**ISD #15 DISTRICT OFFICE BUILDING
4115 AMBASSADOR BLVD.
October 17th, 2018**

City of St. Francis Planning Department
Rivers Edge 2nd Addition Development Stage PUD Review

To: Planning Commission
From: Beth Richmond, City Planner
Meeting Date: 10-17-18
Applicant(s): St. Francis Land Development, LLC (Dale Willenbring)
Location: Outlot A, Rivers Edge 1st Addition

Rivers Edge Phase 2 Stormwater Management Plan, dated 7/31/18, prepared by Civil Methods, Inc.

PRELIMINARY PLAT	PROJECT NO: job no.
SHEET NO. 4 OF 10 SHEETS	DATE: 07/31/2018

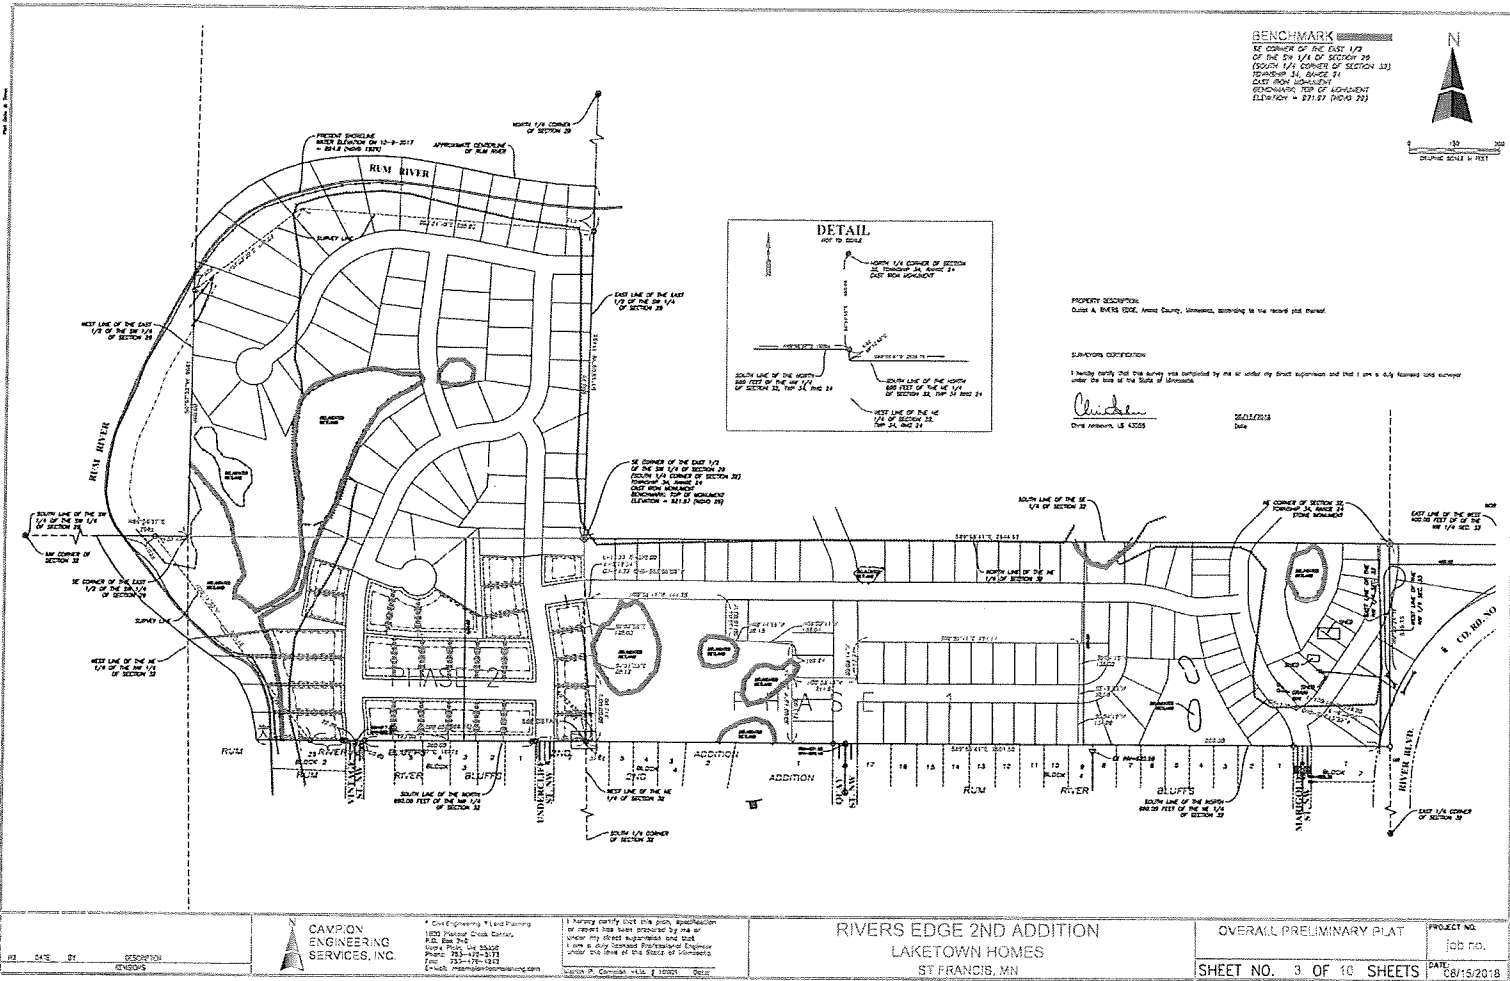
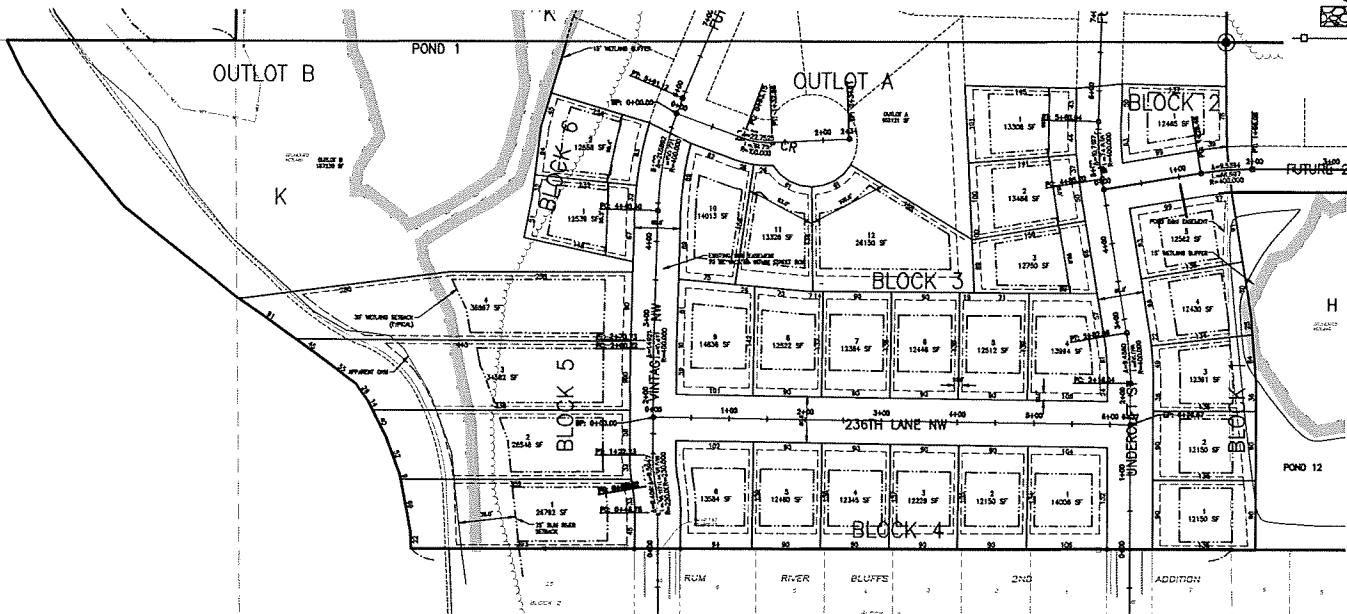
2. The preliminary plat shall be revised to include the locations of the existing houses on Lot 25, Block 2 and Lot 7, Block 4, Rum River Bluffs 2nd Addition.

3. The preliminary plat shall be revised to label bearing and distance of the exterior boundary lines of the plat.
4. The preliminary plat shall be revised to dimension easements.

5. The preliminary plat shall be revised to depict the existing watermain easement.
6. The proposed preliminary plat is within two zoning districts. The preliminary plat shall be revised to clearly depict which lots are R2 zoning, and which lots are Rum River Scenic zoning.

7. All wetlands, stormwater basins, storm sewer pipe, and floodplains shall be within a drainage and utility easement. The preliminary plat shall be revised to depict proposed drainage and utility easements over these features.

PRELIMINARY GRADING PLAN

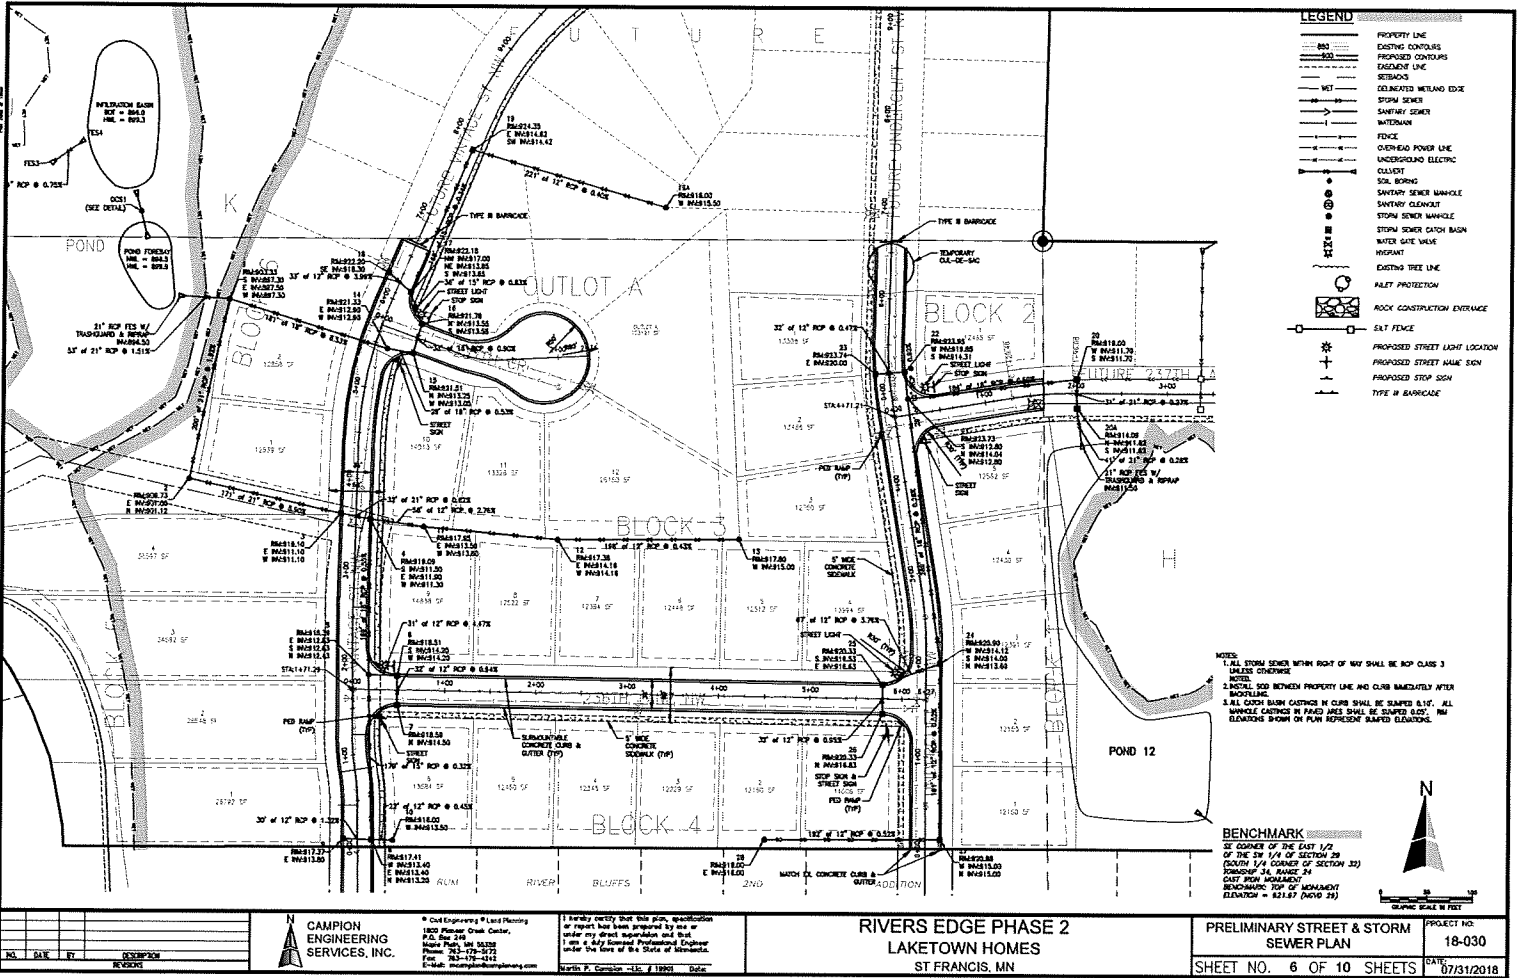
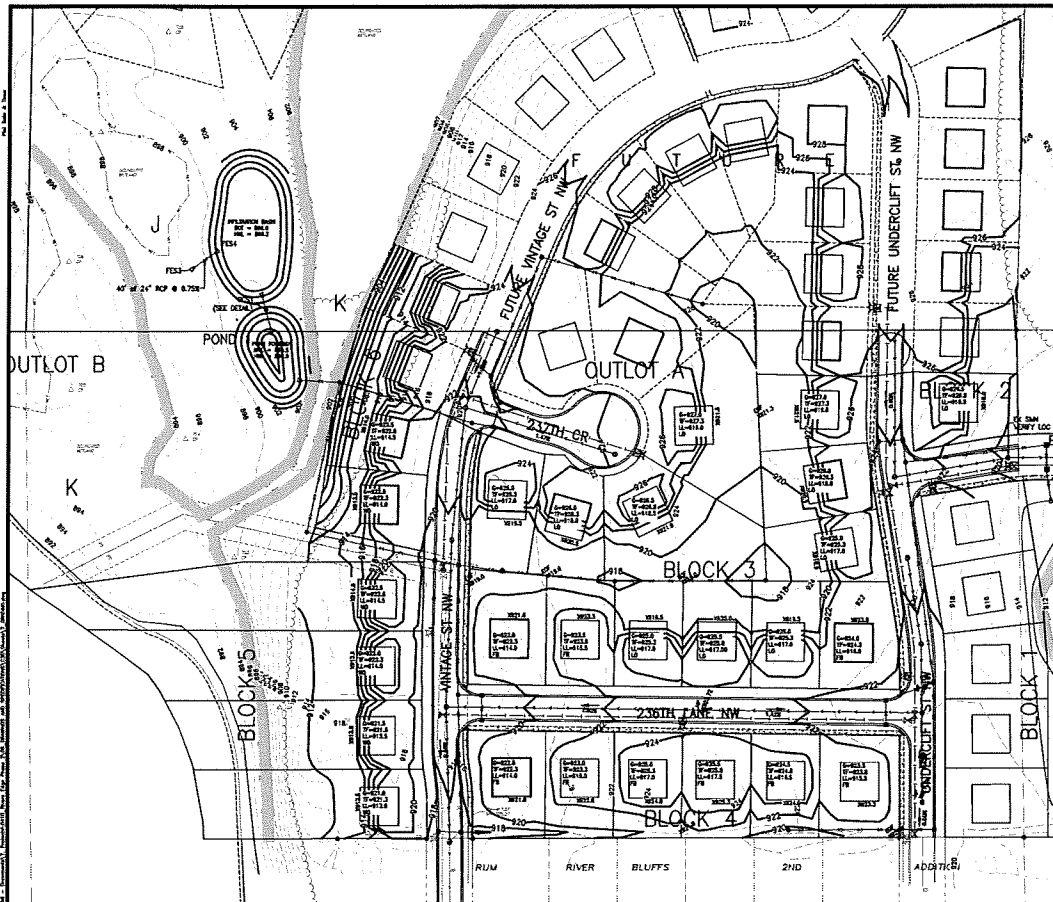
4. The emergency overflow elevation between Block 5 and Block 6 west of Vintage Street shall be labeled on the plans.
5. The emergency overflow along Vintage Street for Lot 6 Block 4 and Lot 1 Block 5 shall be labeled on the plans.

6. All lowest openings are required to be 1.5 feet above the emergency overflow elevations (10-93-6.E.4). Please provide proposed lowest opening elevations and ensure the 1.5 foot separation is met.

8. It does not appear that the proposed emergency overflow elevation provides 1.5' of separation from the lowest opening elevation in Rum River Bluffs Lot 2 Block 3. Per the approved Grading Plan, the lowest opening for Lot 2 Block 3 is 921.5, therefore the emergency overflow shall be 920 or lower.

9. A proposed spot elevation of 918.0 is depicted in the rear yard of Lot 1 Block 2. The preliminary grading plan proposes a look out house type for this lot with a lowest level elevation of 918.5, therefore it appears that the spot elevation is incorrect. Please correct.
